**National Committee on  
Seismic Design Parameters (NCSDP)  
for River Valley Projects**

**MINUTES  
OF  
30<sup>th</sup> MEETING  
(15<sup>th</sup> September, 2015)**

**Foundation Engineering & Special Analysis (FE&SA) Directorate  
Central Water Commission  
New Delhi**

**MINUTES OF THE 30<sup>TH</sup> MEETING OF  
NATIONAL COMMITTEE ON SEISMIC DESIGN PARAMETERS FOR RIVER VALLEY PROJECTS  
HELD ON 15<sup>TH</sup> SEPTEMBER, 2015 IN CWC, NEW DELHI**

### 30.3.2 Tawang (Stage-II) HE Project, Arunachal Pradesh

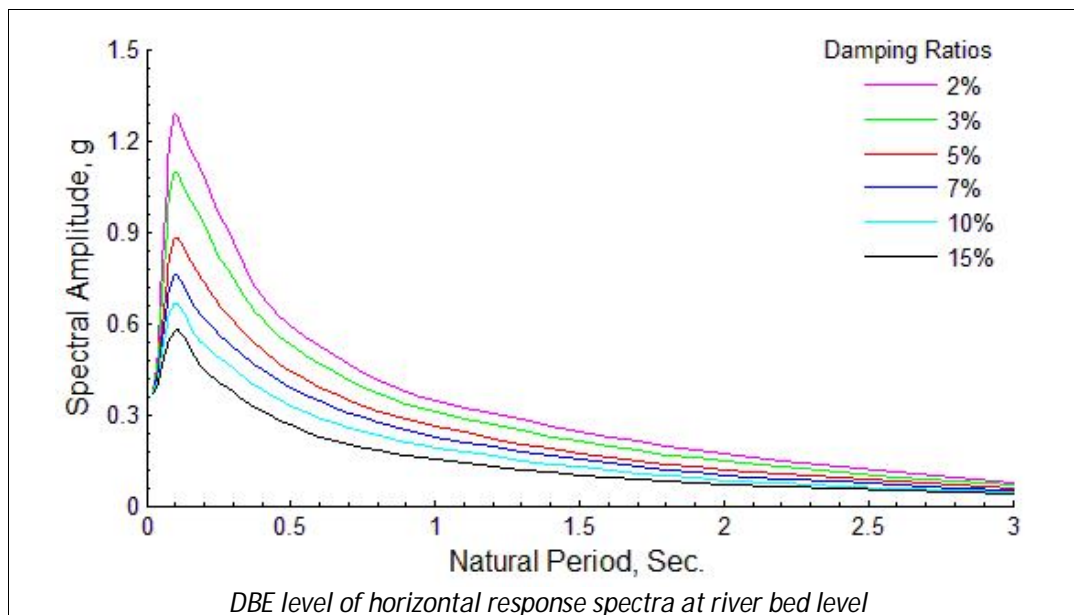
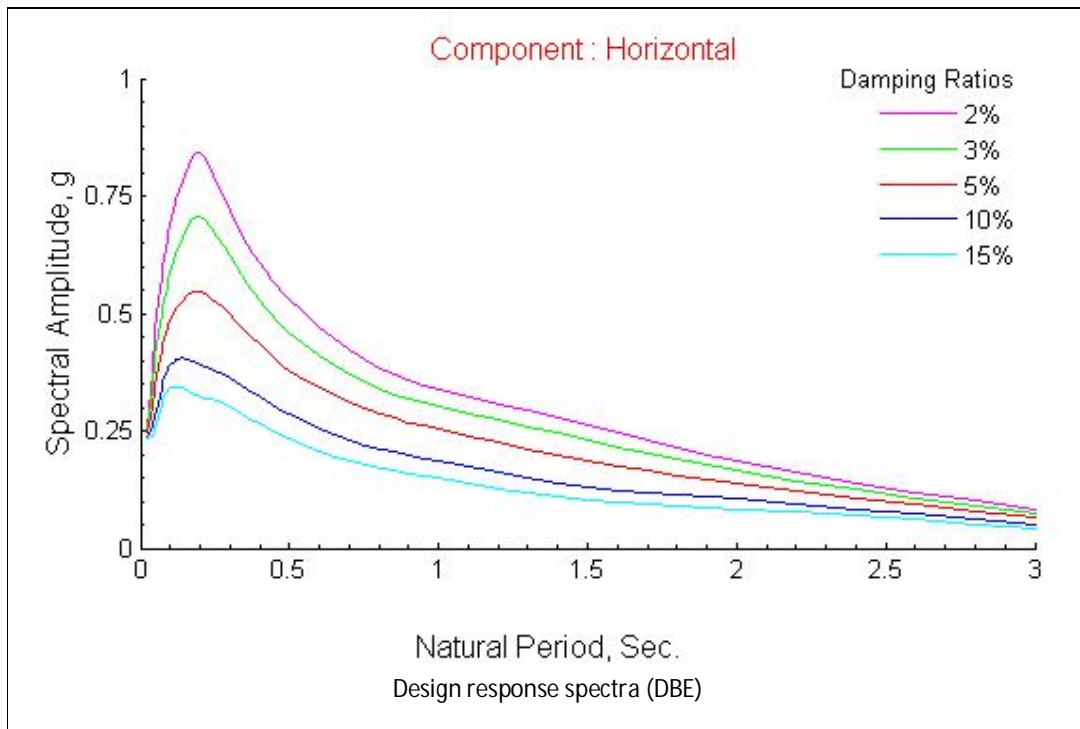
A presentation on the study report was made by the project authorities. During discussion Member Secretary pointed out that the PGA values should be rounded off to two decimal places and the period of strong motion/total duration should be rounded off to an integer value. The representative of CWPRS has agreed and mentioned that the same will be complied in their reports in future.

**After brief deliberation, the Committee accorded approval to the study report of Tawang (Stage-I) HE Project, Arunachal Pradesh. The summarized seismic design parameters of the approved report are as under:**

### 30.3.4 Sawalkot HE Project, Jammu & Kashmir

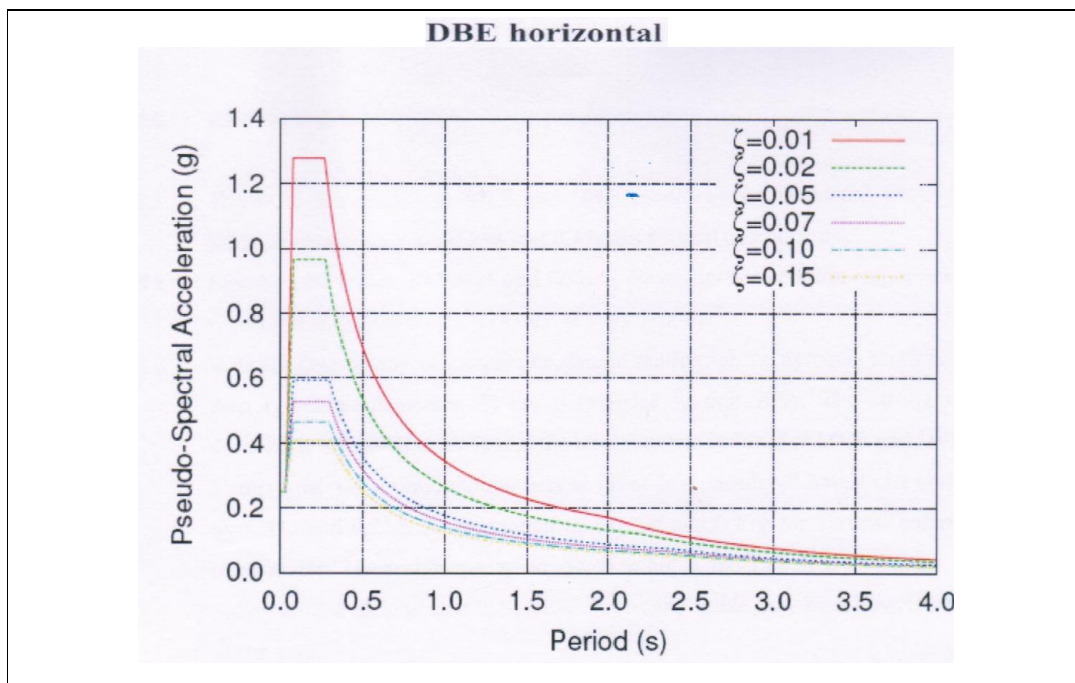
The Member Secretary informed the Committee that the project authorities have submitted the updated copy of the study report (IIT Roorkee Report (EQ: 2014-31; Project No. 6042/12-13 (August-2015)) incorporating the spectra for 15% damping and safety criterion. A presentation on the study report was made by the project authorities. The project authorities have informed that MEQ studies for 193.0 m concrete dam will be taken up shortly and final study report will be submitted by September, 2016.

**After brief deliberation, the Committee accorded approval to the study report of Sawalkot HE Project, Jammu & Kashmir. The Committee also noted that its approval is conditional subject to the submission of MEQ studies by the project authorities by September, 2016. The summarized seismic design parameters of the approved report are given below:**

### 30.3.5 Lakhwar Multi-Purpose Project, Uttarakhand

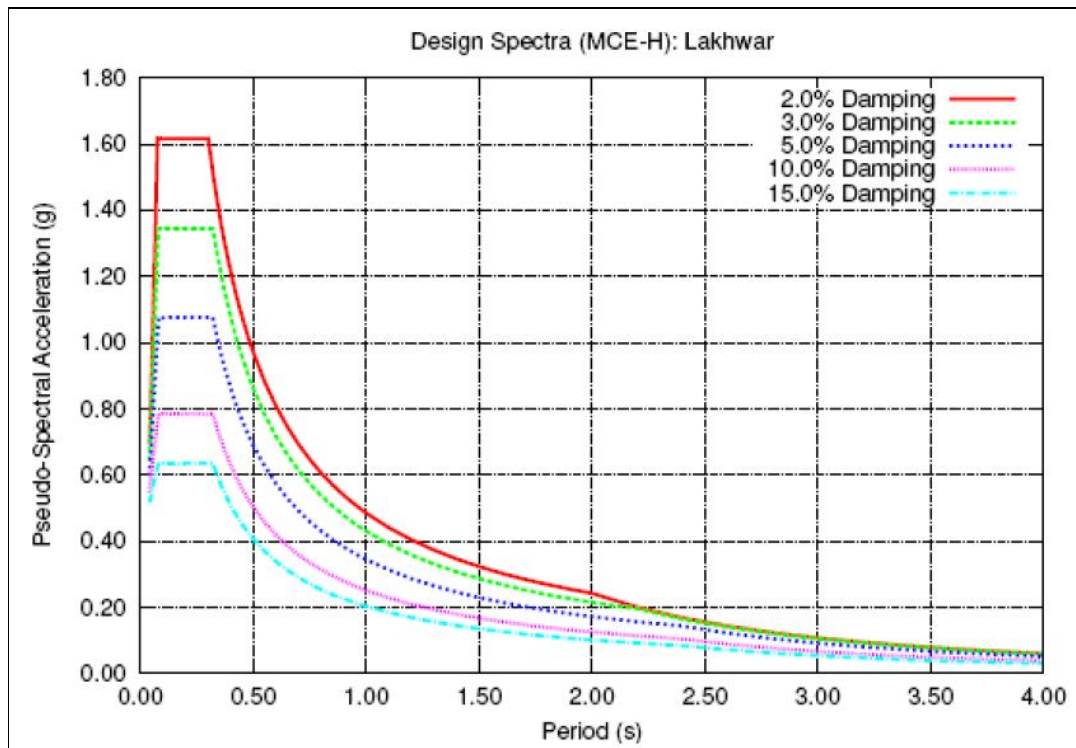
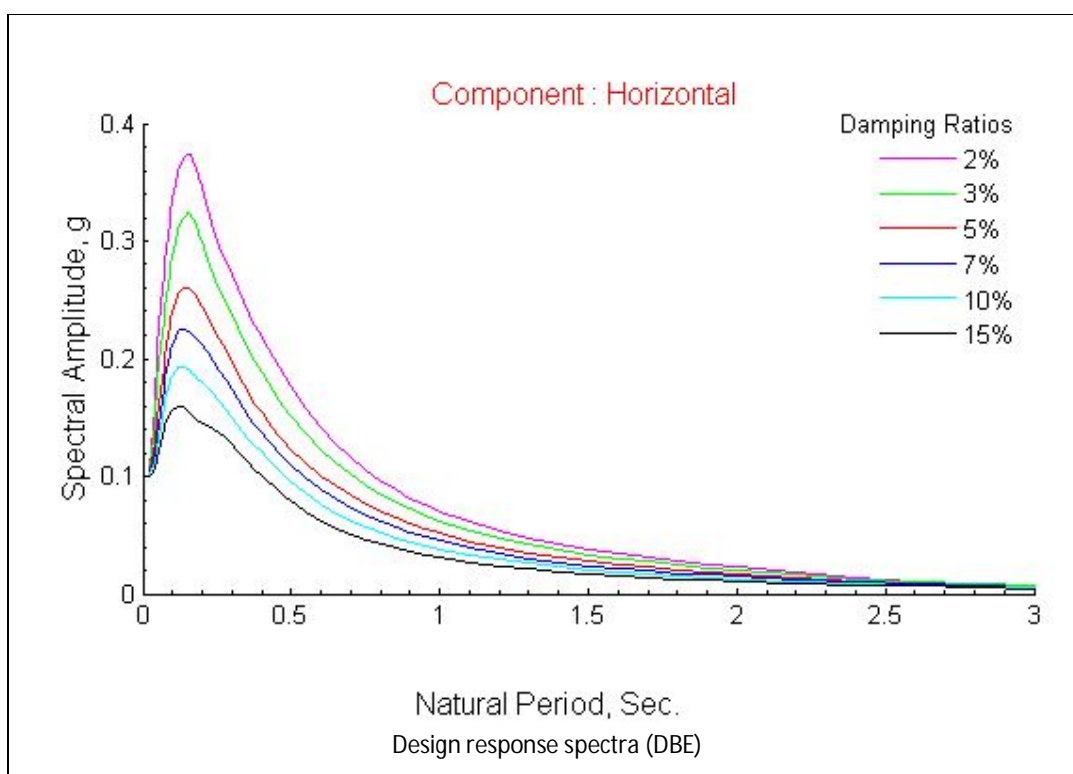
A presentation on the study report was made by the project authorities. The project authorities have informed that MEQ studies for 204 m concrete dam will be taken up shortly and final study report will be submitted by September, 2016.

After brief deliberation, the Committee accorded approval to the study report of Lakhwar Multi-Purpose Project, Uttarakhand. The Committee also noted that its approval is conditional subject to the submission of MEQ studies by the project authorities by September, 2016. The summarized seismic design parameters of the approved report are given below:
